APPENDIX EE: DESIGN INTEGRITY REPORT

**Pitt Street North Over Station
Development**

State Significant Development,
Development Application (SSD DA)

29 June 2020

Refer Architectural Design Report Section 2.12.

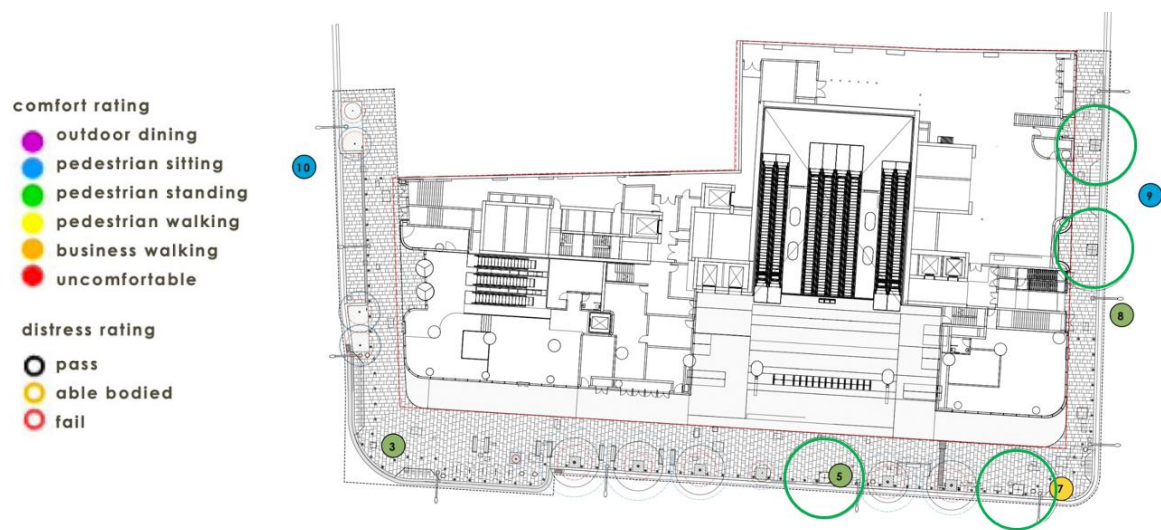
2. Tree planting is supported with further City of Sydney coordination. Further refinement required including the development of a strong set of principles to ensure a positive outcome.

- Two new kerbside trees are proposed at street level along Castlereagh Street, continuing the new trees that have been introduced in front of the Liberty place entrance. Additionally, two new infill trees have been introduced on Park Street at grade where they are completing the already existing tree line, lending the tower a green entry, separating seating from the kerb and bus stop to enhance the quality of waiting spaces. This establishes a continuous canopy of street trees that visually and ecological link each site to Hyde Park and Darling Harbour and gives these cross streets a clear identity that helps anchor and situate both locals and visitors at the midpoint in the City.

- In depth wind studies have been undertaken by the wind engineer in order to ascertain the impact wind will have on the trees and their ability to grow and thrive. The analysis concluded that the existing wind conditions and proposed building massing will not negatively influence the viability of the street trees.

Refer Architectural Design Report Section 3.13.

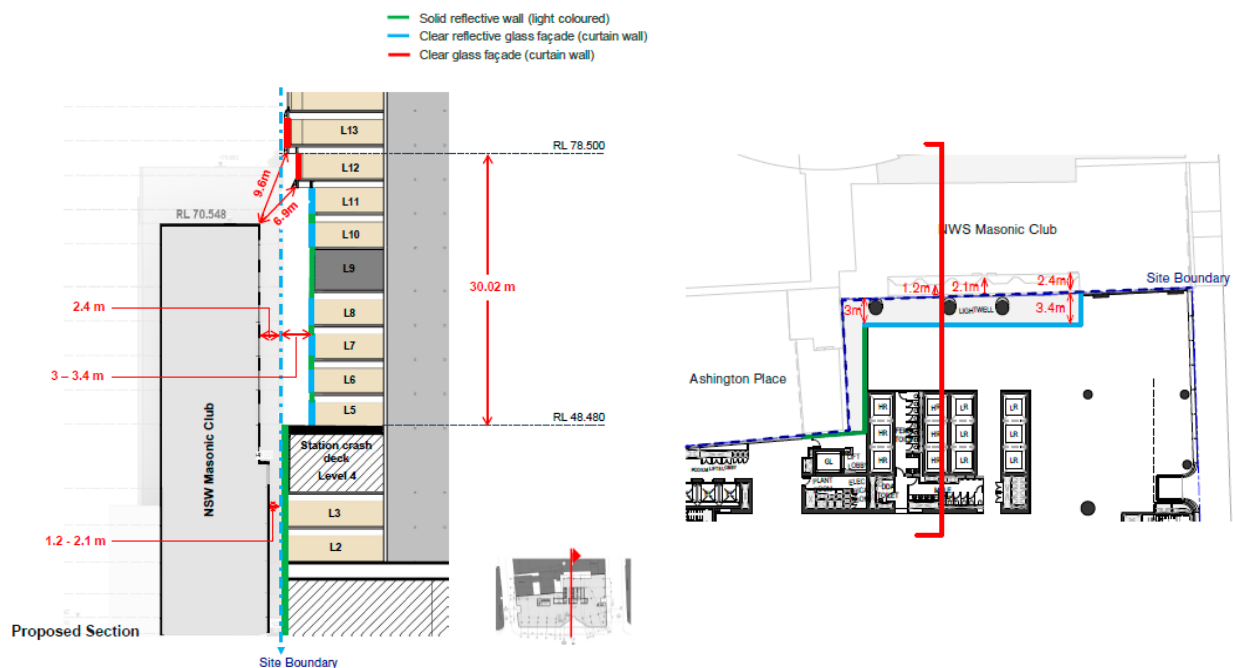
3. Design of the station entry should be refined to reduce the imposition of structural beams on the experience. Reconsider elements that are not critical to achieve a simple, grand entry commensurate with the Park Street location.

- The structural design of the station entrance skylight has undergone an in-depth review by the structural engineering team in conjunction with the project's Blast engineer. Requirements listed within the Sydney Metro imposed Scope of Works and Technical Criteria's (SWTC) determine the maximum size of the glazed elements as well as the minimum size of transoms and mullions which capture the glass panels. All structural elements have been reduced to their smallest size allowing the maximum amount of daylight access to the station entrance.

Refer Architectural Design Report Section 1.11 & 3.17

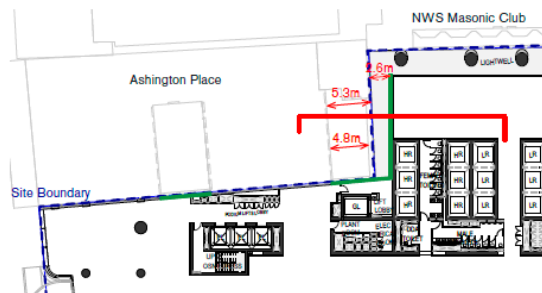
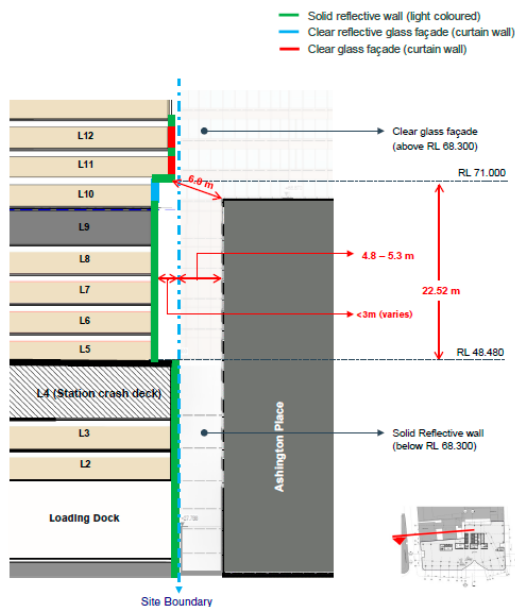
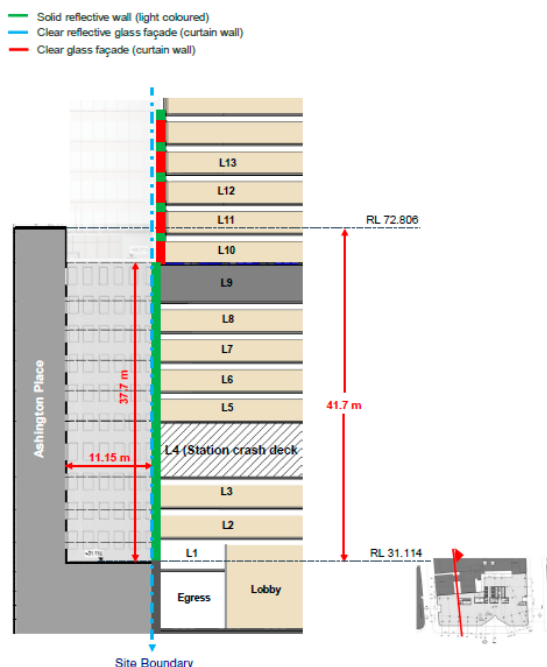
4. Light well to the northern boundary to ensure an appropriate relationship to adjoining building to the north and the tower above.

- In line with the Pitt Street North Design Parameters set for the development, the proposed western facade of the OSD tower is providing a set-back between 1.9 and 2.6m from the site boundary for the length of the Ashington Place light well for six levels above the Station transfer level on level 4. The proposed podium and tower facades from level 5 to 9 are required to be clad in reflective light-coloured solid materials to maximise daylight access into the Ashington Place commercial offices surrounding the lightwell. As shown in the section below, level 10 will be the first level to have clear glazing as it is located above the roof of Ashington Place.

- The northern facade of the OSD podium and tower near the North-western corner of the site is immediately adjoining the Pitt Street North site boundary and thus providing a set-back of 0m. In line with the Pitt Street North Design Parameters set for the development, the proposed podium and tower facades from level 1 to 9 are required to be clad in reflective light coloured solid materials to maximise daylight access into the Ashington Place commercial offices surrounding the lightwell, with clear glazing proposed from level 10 onwards, as shown on the diagrams below.
- As such, the design of the facade which are facing the heritage lightwell with Ashington Place fully complies with the project requirements established in the OSD North Design Parameters during the RFT phases of the project.

Refer Architectural Design Report Section 3.9 & 3.10

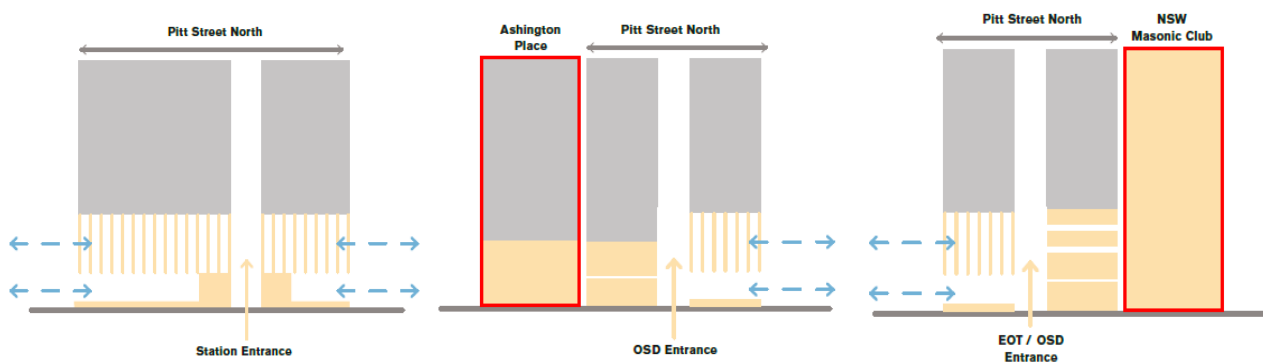
5. Further refinement of the facades: detail and materiality. This includes further attention to the detail of the sandstone at ground level to achieve an appropriate civic response.

- The identity of Pitt Street North reflects the geological rock formation that it sits on top of. For the external and internal building facades, a local sandstone has been selected; 'Piles Creek Cream' stone panels from the Gosford quarries. The sandstone panels will be applied with grouted, sealed joints colour-matched to the stone panels.

(b) Heritage response on Castlereagh Street (DRP No.3 & No.7)

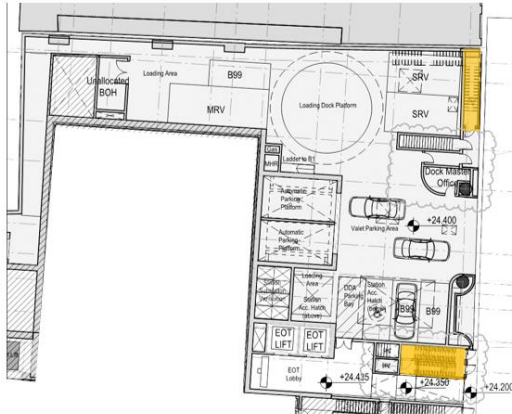
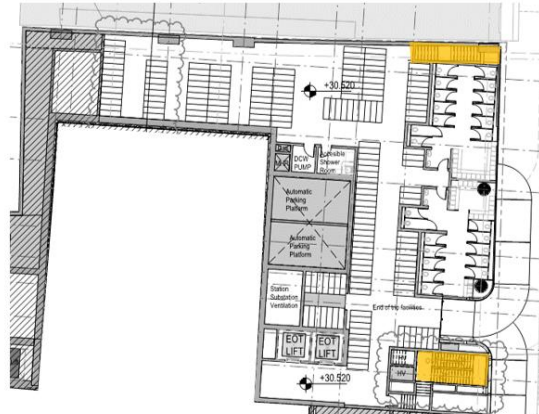
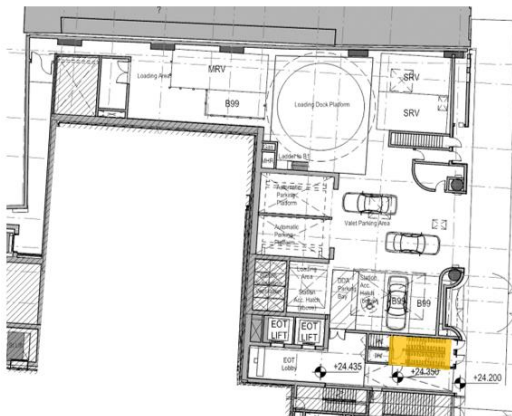
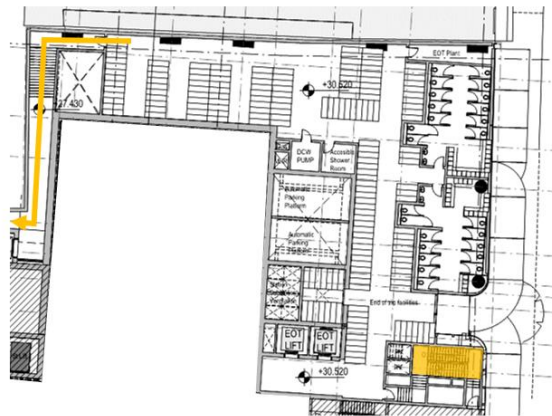
- During the RFT stages, the Heritage Interpretation Strategy was anticipated to manifest in the form of a number of display cases of varying heights placed below the End of Trip Facility (EOTF) egress stair on Castlereagh Street. The initial idea was to continue the story of the heritage display cases within the neighbouring Liberty Place along Castlereagh Street.

- During the design development stages, the design team was able to remove the EOTF stair, by re-arranging the egress strategy on level 01 and as a result allow for a more flexible layout of the heritage display cases on ground floor.

Heritage Displays

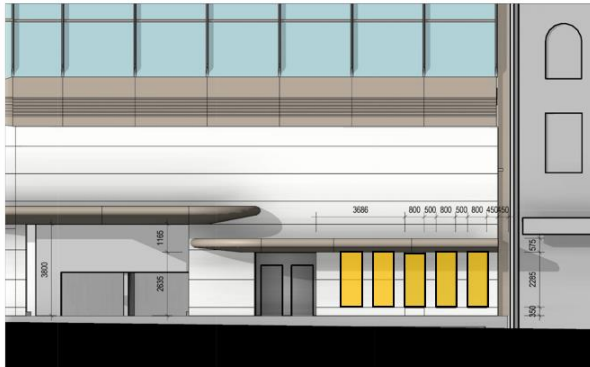
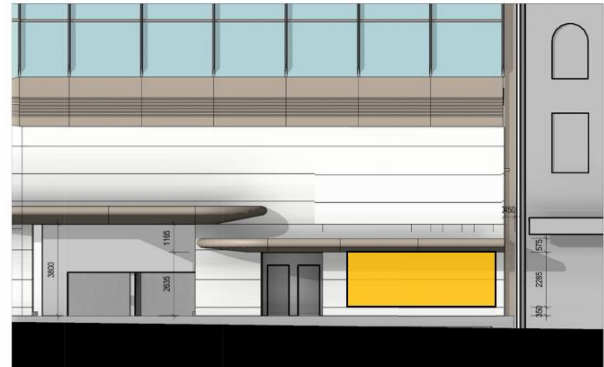
- The Panel noted that they accepted the modifications to the facade Castlereagh Street to improve design relationships with adjoining buildings and heritage display strategies. The Panel also mentioned that they looked forward to the developed design of heritage interpretation panels. The Panel didn't specifically select one of the two options at the time.

- During DRP No.3 on the 17th of December 2019, the design team presented 2 different options to the Design Review Panel; Option 01 shows 5 individual display case of a similar size. While option 02 showed one large display case, as indicated in the below diagrams which were presented to the panel.

L10/11 Balustrades Building Envelope

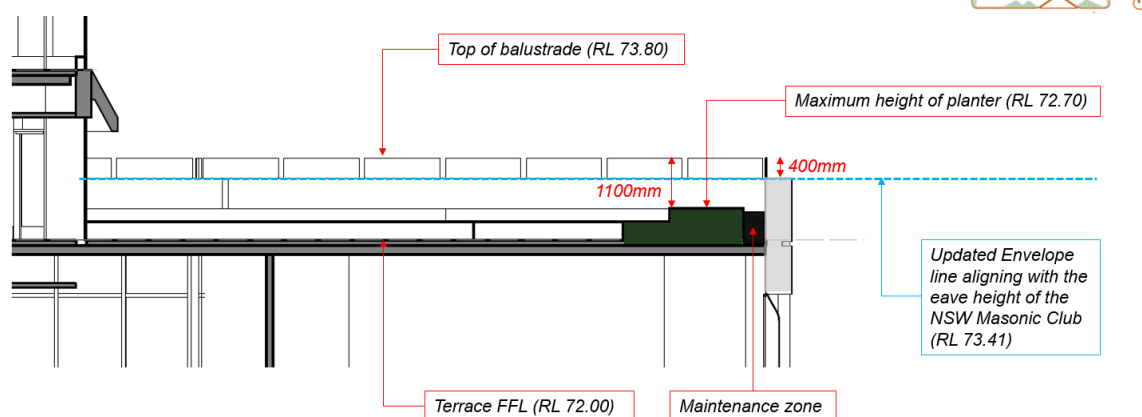
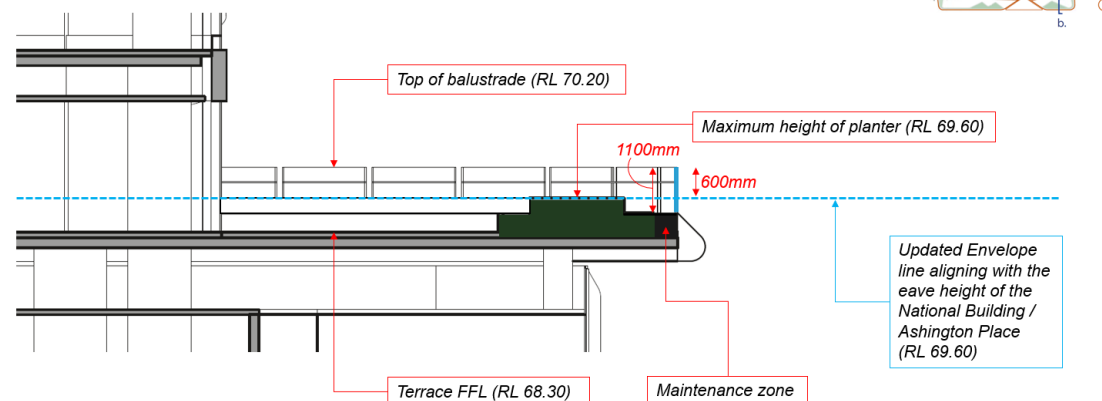
Item 7.06 – The Panel is concerned that screening the podium setback on the corner with 1.8m glass balustrade in order to moderate the impact of wind for podium users, will in turn negatively impact the wind conditions on the street that the setback has been designed to mitigate. The panel recommends further wind studies be undertaken to assess this.

The design team presented the following two diagrams during DRP No.9, indicating that the height of the balustrade would be at 1.1m high from the top of the planter bed, creating a compliant height balustrade around the perimeter. Details of the presentation can be seen in the images below.

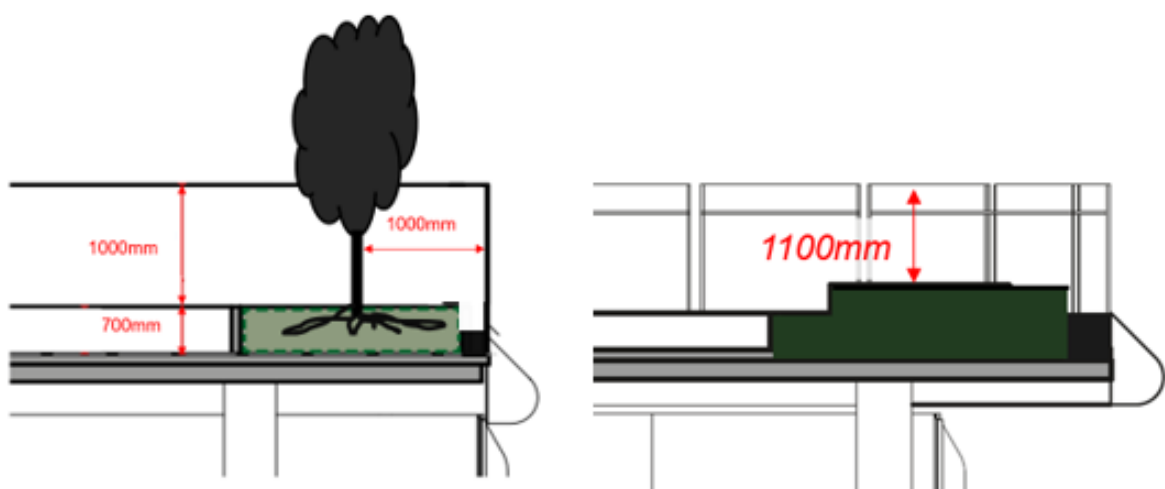
Item 7.07 - The Panel notes that a code compliant balustrade would be required on the outside edge of any planter to prevent falls and seeks (additional information?) regarding the interface of the landscape and the balustrade edge.

The design team also presented a number of slides outlining that; as a minimum the BCA requires that a 1m high balustrade be provided where there is a potential for a fall of 1m or more from the trafficable surface as per clause D2.16.

With regards to the trees within the planter, to avoid any potential climbing issue, trees are to be planted a minimum of 1m away from the balustrade, as per the first diagram below. The second diagram demonstrates that a 1,100mm high balustrade is proposed which will meet the minimum height requirements lifted in clause D2.16. of the BCA.

Ashington Place (East)

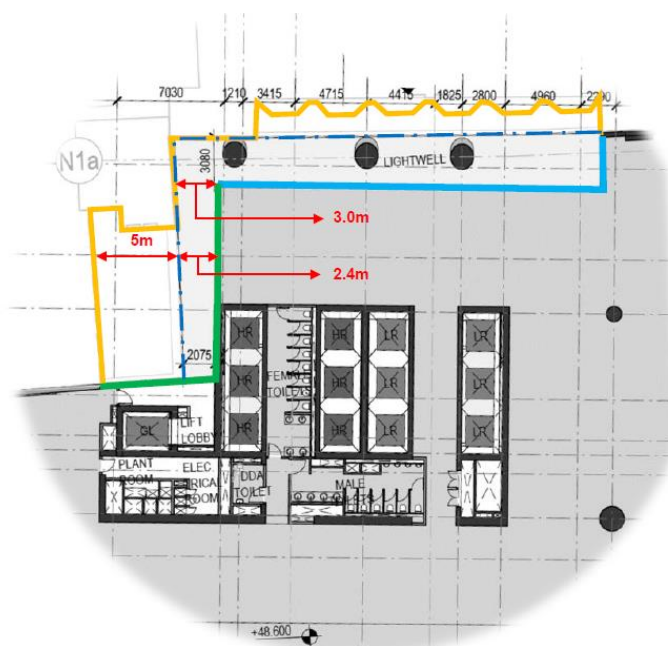
After the presentation the notes from the DRP panel read as follows:

During DRP No.6 on the 17th of March 2020 the design team presented a further update to the Eastern Ashington Place lightwell after investigating the natural daylight access to the Pitt Street North level 5 to level 8 commercial floors. The decision from the design team was that the north facing façade already provided some daylight access to the floorplate, the west facing façade would not greatly improve the daylight conditions as a result of overshadowing from neighbouring buildings. Furthermore, this façade was also located less than 3m away from the property boundary and thus could not include clear glazing elements. The proposed façade treatment was to maintain a solid light-coloured reflective façade to the entire west facing facade in line with the diagram below and the original OSD Design Parameters set out for the project during the RFT phases.

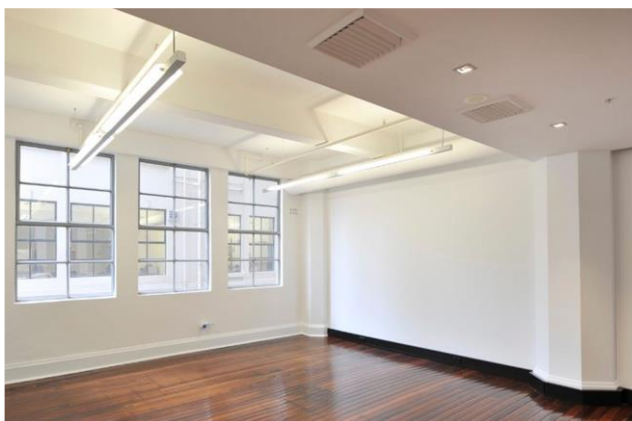
The final note from the DRP panel listed that the panel members supported the proposed approach to the materiality of all Ashington Place lightwell facades.

During DRP No.6 the design team also presented a further update to the Western Ashington Place lightwell after investigating the outlook that currently can be experienced by the Ashington Place commercial tenants. The design team concluded that there would be no additional benefit to the tenants if a special treatment would be introduced on the North facing lightwell wall, given the outlook is predominantly in an east-west orientation. Furthermore, the design team felt strongly about replicating the look and treatment to the existing lightwell walls on the north facing wall for consistency and to maintain the overall character of the lightwell and more generally the character of the heritage building itself.
